Groundwater Application Review Summary Form

Application # G- 18745

MEMO

PUBLIC INTEREST REVIEW FOR GROUNDWATER APPLICATIONS

Figure 1. Water Availability Tables

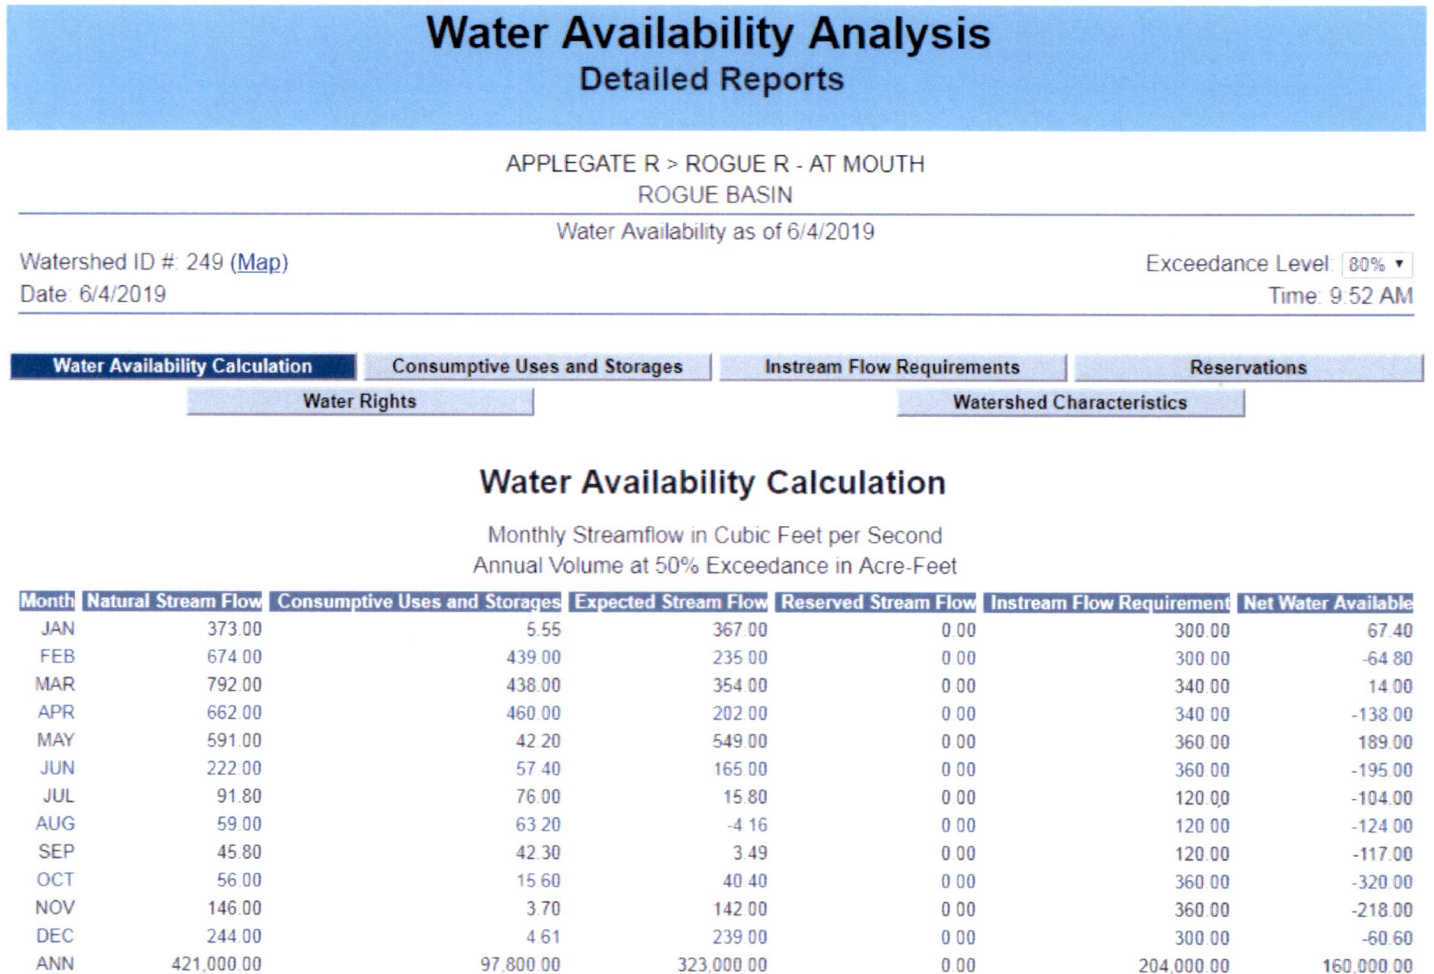
C6. **SW / GW Remarks and Conditions:** The applicant's wells access an aquifer that has been determined to be hydraulically connected to Slagle Creek and the Applegate River. The combined rate of appropriation on the applicant's wells (0.628 cfs) is greater than 1% of the 80% exceedance flows in the relevant Water Availability Basin (1% of 45.8 or .458 cfs). As a result, the proposed uses have the Potential for Substantial Interference (PSI) as per OAR 690-009.

The applicant can reduce the overall rate of appropriation on the proposed POAs to less than 0.458 cfs (~205 gpm) to avoid a finding of PSI.

Figure 3. Water-Level Trends in Nearby Wells

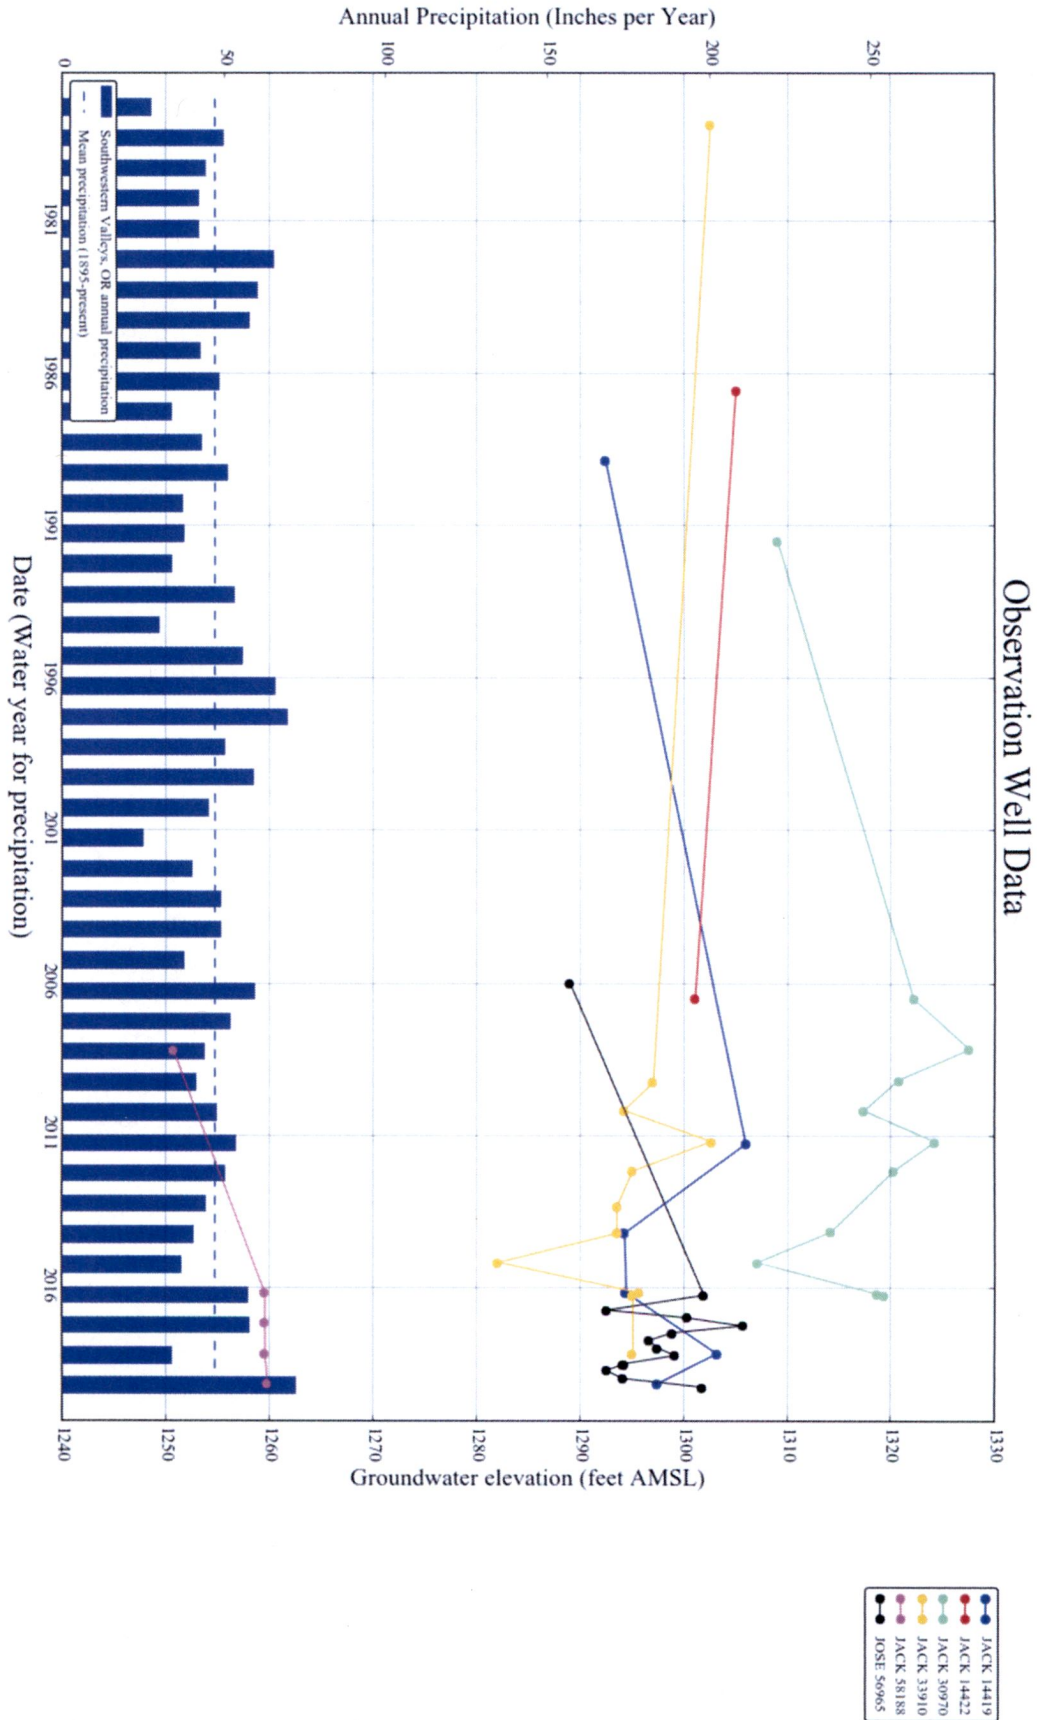
B3. **Groundwater availability remarks:** Water level data from wells adjacent to the applicant’s proposed POA indicate that aquifer levels are relatively stable; fluctuations track with climatic and seasonal precipitation trends. There are several groundwater rights within 1 mile of the applicant’s proposed POA, posing the risk of well-to-well interference so water-level reporting and standard interference conditions in B1(d) should be applied. At this time, the Department is unaware of well-to-well interference complaints in the immediate vicinity. Considering stable water level measurements, the low requested rate, and lack of known interference issues, it is unlikely that the proposed use/rate would result in injury to other permitted water rights with the appropriate permit conditions applied.
